## LIVERPOOL HOSPITAL – Infrastructure & Ancillary Hospital Works

MP 08\_0062 MOD 1

Modification of Minister's Approval under section 75W  
of the *Environmental Planning and Assessment Act*  
1979

**Figure 2 – Proposed Modification to Hume Highway Intersection**

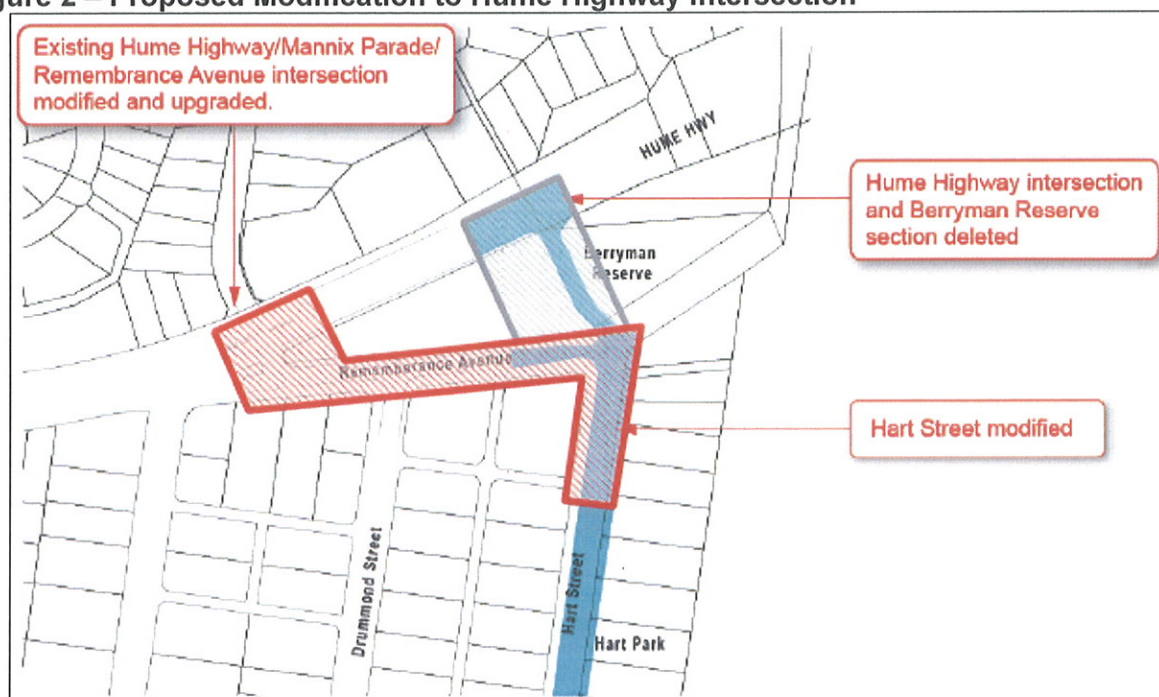
This modification request seeks approval to amend the proposed development of the Hart Street extension through Berryman Reserve and the new intersection with the Hume Highway by rerouting Hart Street traffic via Remembrance Avenue to the existing Hume Highway/Mannix Parade/Remembrance Avenue intersection and carrying out upgrading works to that intersection, as can be seen in **Figure 2** below.

Pursuant to Condition B3, the proponent has been in discussions with the RTA and Liverpool Council with particular attention being given to issues of concern related to the intrusion of Hart Street into Berryman Reserve, the removal of trees in Berryman Reserve and the location of the proposed new Hume Highway intersection close to the crest of the railway overpass.

In response to these concerns the proponent agreed to pursue an alternative access arrangement which would utilise the existing Hume Highway/Mannix Parade/Remembrance Avenue intersection to access Hart Street and the redeveloped Liverpool Hospital.

Figure 4 illustrates the proposed changes to the approved intersection scheme.

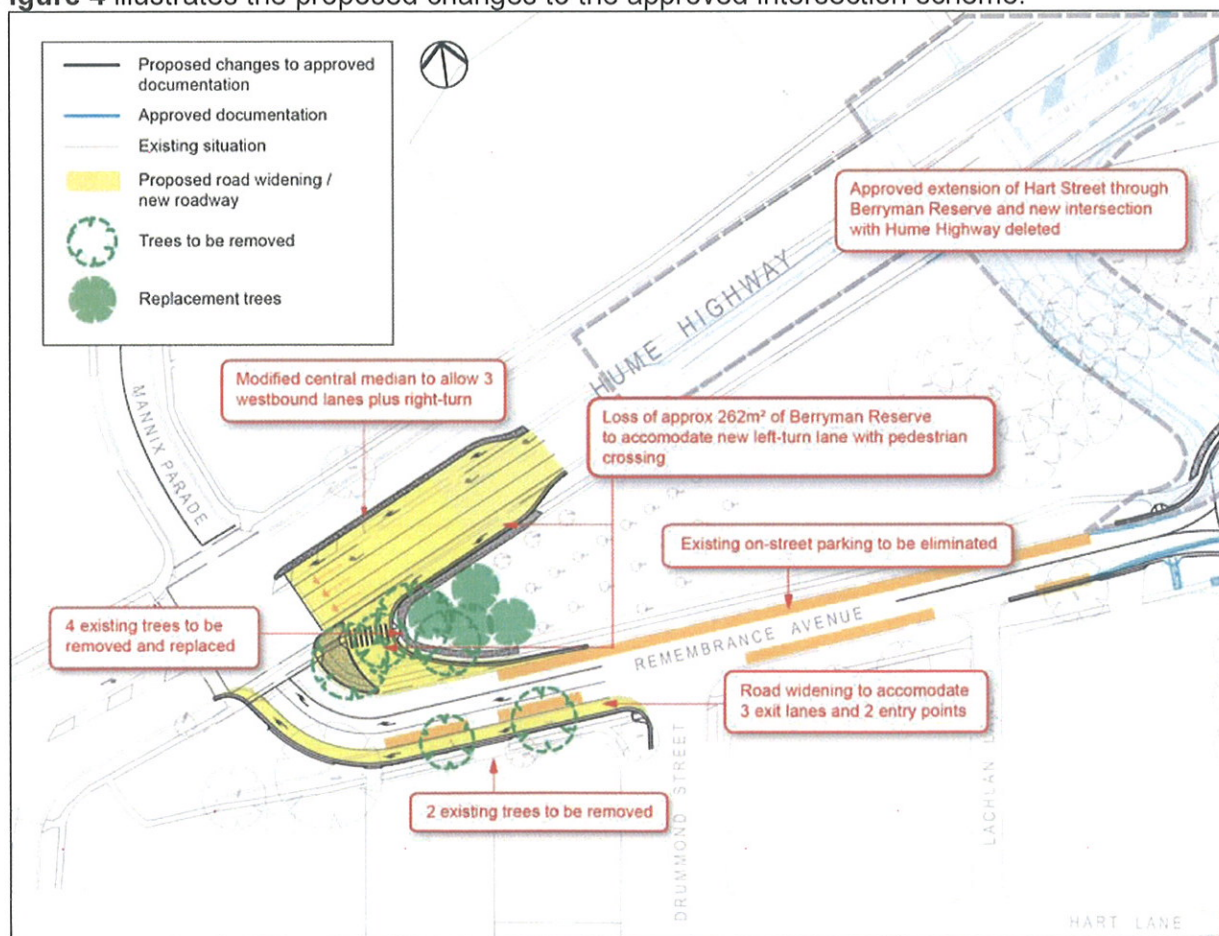
The RTA responded further on 9 December 2010 stating that they would not fully support the layout of the proposed modified intersection as illustrated in Figure 4 of the submitted documentation (shown as **Figure 4** in this report). In particular, they sought the following amendments:

- Double diamond overlap phasing shall be provided for all right turn movements at the intersection of Hume Highway, Remembrance Parade and Mannix Parade;
- The stop line at Hume Highway east approach shall be rectified to allow for the provision of a pedestrian crossing on the eastern leg of the intersection; and
- Two right turn lanes and one share left/through lane shall be provided on the Remembrance Parade approach to the intersection.

The RTA confirmed however that they did not object to the approval of the application provided that these issues were addressed at the detailed design stage. The proponent has confirmed that they are willing to accept this as a condition of approval.

Figure 5 illustrates the proposed change to the approved scheme.

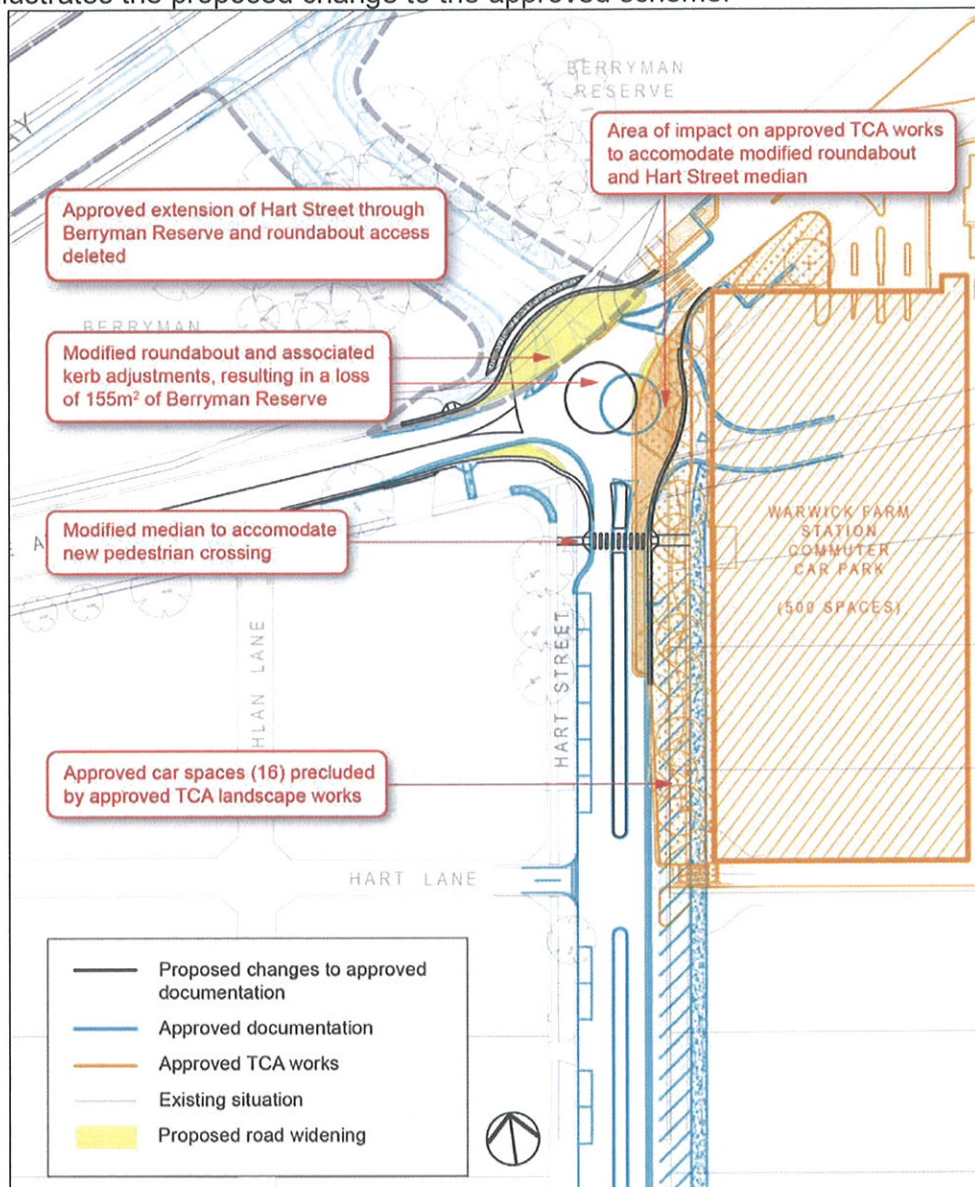
It is proposed that the approved five-way roundabout at Remembrance Avenue and Hart Street be revised to a three-way roundabout, reflecting the proposed deletion of the Hart Street extension north through Berryman Reserve as well as the new access arrangement for the Warwick Farm Station Commuter Car Park.

A new pedestrian crossing is also proposed south of the roundabout to provide pedestrian access to the car park. This will require modifications to the approved kerb and footpath alignments and to the central median on Hart Street to provide for the pedestrian crossing.

Safe pedestrian access across Hart Street to the multi-deck car park and train station beyond via the new pedestrian crossing in Hart Street is seen to be an improvement over the approved scheme.

Whilst there will be a reduction of 16 car parking bays on the eastern side of Hart Street, this will be more than offset by provision in the new commuter car park.

The modified intersection arrangements at Hart Street/Remembrance Avenue will result in a small loss of open space. However this is considered minor compared to the impact on Berryman Reserve at this point in the approved scheme, where a new road through the reserve would result in the loss of a number of mature trees. The proposed modification is seen as an improvement over the approved scheme.
